## KM 175 HARSH SHIFTS (SERVO SEAL)

### PURPOSE

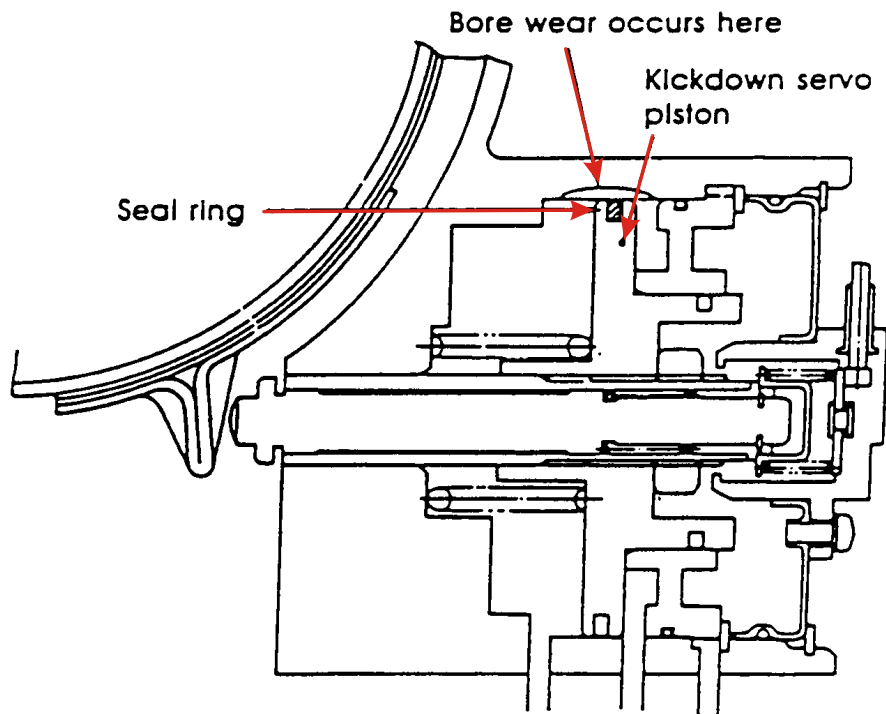
These symptoms may be due to the kickdown servo piston not releasing properly. This Is caused by hydraulic fluid leaking past the seal ring of the servo piston as a result of wear In the piston bore (Figure 1). Because wear of the piston bore varies between vehicles, the severity of the symptoms will also vary.

Figure 2

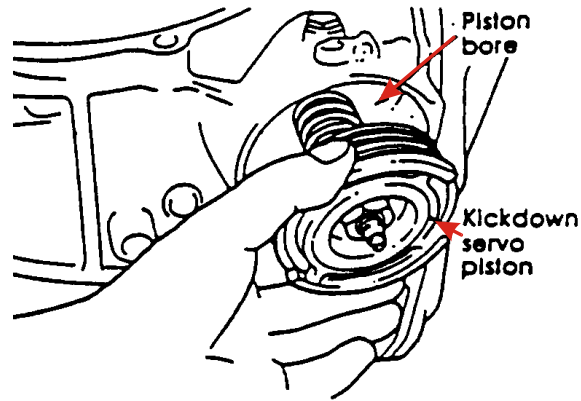
If hard shift symptoms are exhibited, remove the servo piston assembly from the transaxle and check the piston bore (transaxle case) for wear (Figure 2). If the bore wear is less than 0.023 In. (0.5 mm), the hard shift symptoms can be improved by installing a D-ring repair kit (P/N MD728665). This kit contains a rubber piston seal ring instead of the carbon material seal ring installed at the factory (Figure 3).
